# Access Compliance Report Public Rights-of-Way (Curb Ramps)

Main Street: BIMINI\_DR Cross Street: CAMBERA\_LN Location: SE

ADA ID: RPRK211013131428 Ramp Type: Type 1 - Perpendicular Diagonal Initial Pass/Fail: Pass Overall Compliance: No Severity Score: 20

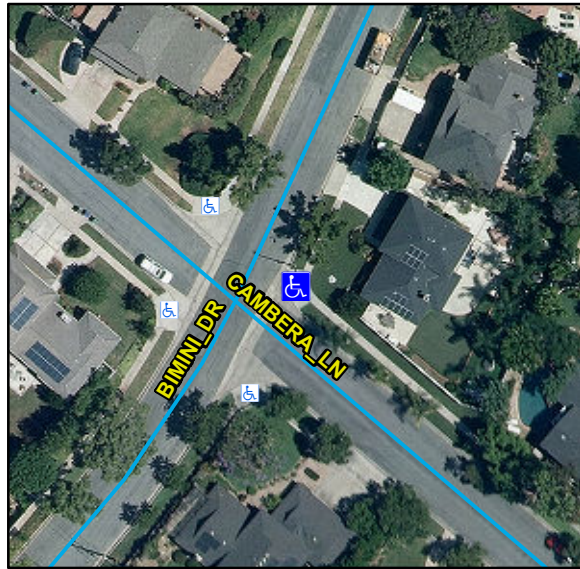
| Compliance | Description                           | Data | Compliance | Description                   | Data   |
|------------|---------------------------------------|------|------------|-------------------------------|--------|
| No         | Landing Width (in)                    | N/A  | N/A        | Flare Slope RT (%)            | 4      |
| No         | Landing Run Slope (%)                 | N/A  | N/A        | Flare Traversable RT          | No     |
| No         | Landing Cross Slope (%)               | N/A  | No         | DWS Provided                  | No     |

Remove & Replace Curb Ramp With Two New Directional Ramps or Equivalent.
